Tree Impact Analysis

Sunnyvale Town Center Block 3 Landscape and Parking Lot Plan Set Iteration 12/19/2016

Report:

WLCA

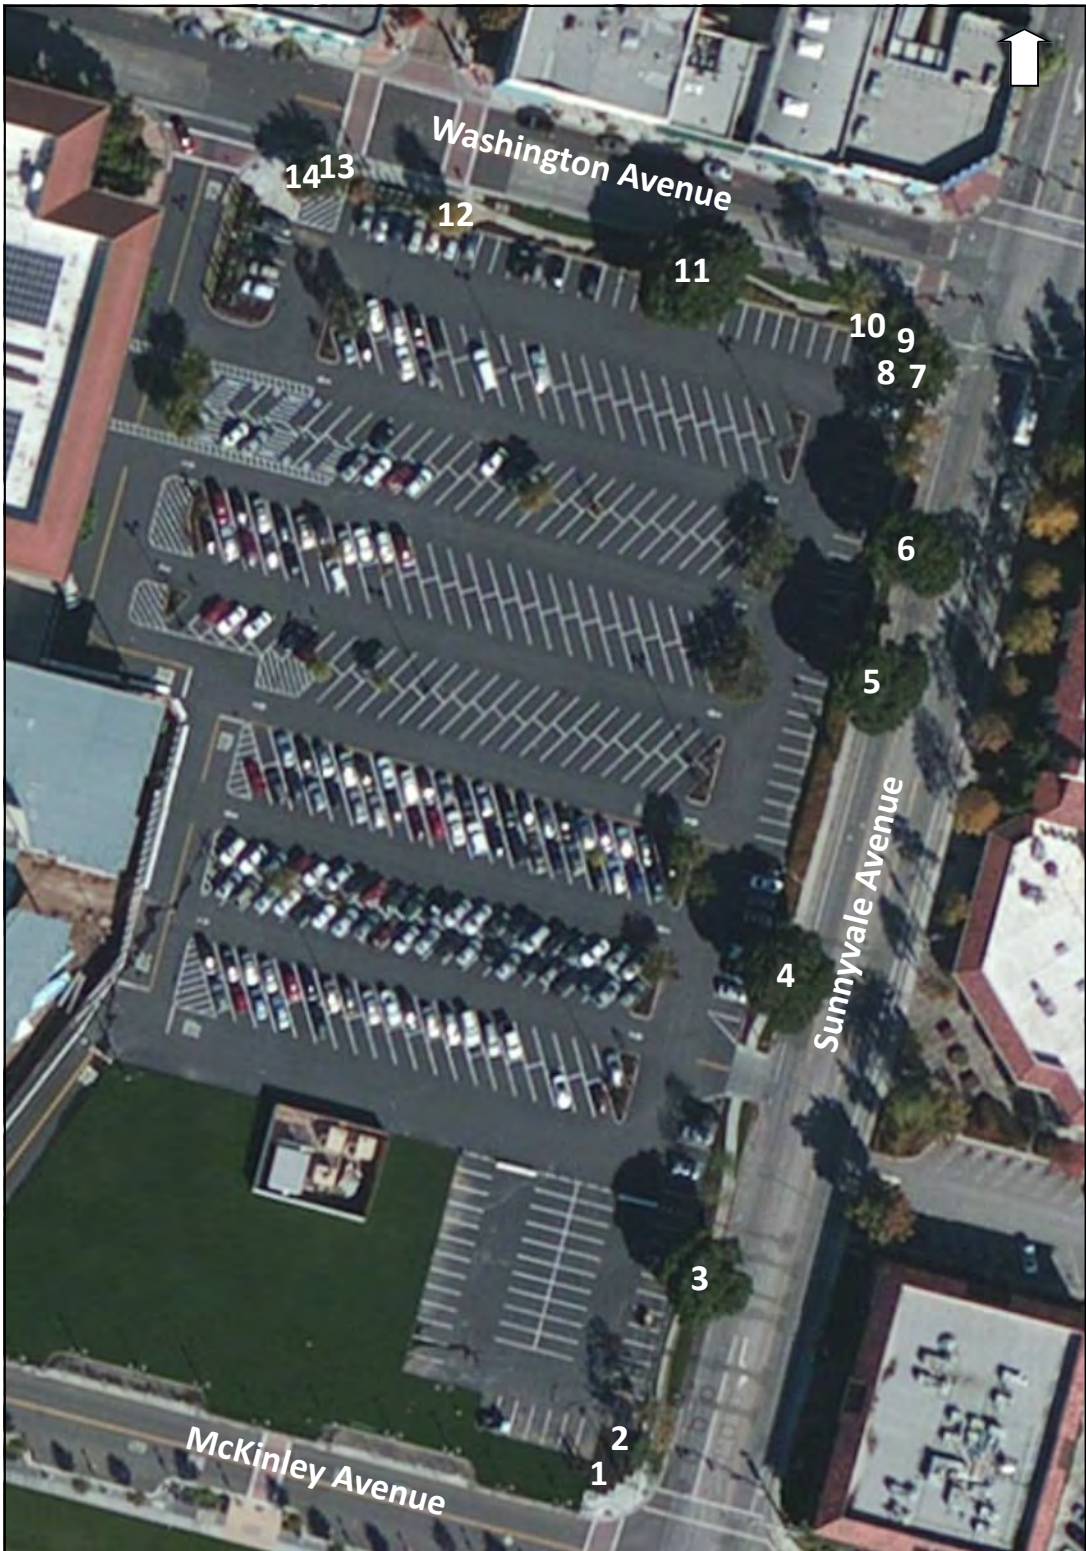
WLCA has included a marked-up version of the proposed landscape layout plan sheet L2.1 below which shows the plot locations of trees #1 through #6.

Note however that the root protection zone (RPZ) temporary chain link fencing as shown on this landscape architect rendered sheet is not entirely correct. The actual on-the-ground fence routing is approximately 50 feet width east to west orientation along the areas adjacent to trees #4, 5, and #6, contrary to the narrow fence routing shown on the map which indicates a distance of only approximately 25 to 30 feet.

The importance of this distinction between actual fencing on-site versus the map-shown fencing is that the true area of redwood tree root zone currently being preserved at the site is quite large in comparison to that shown on the plans. This means that a significant portion of the redwood trees' root zones may be damaged or destroyed during parking lot and landscape development.
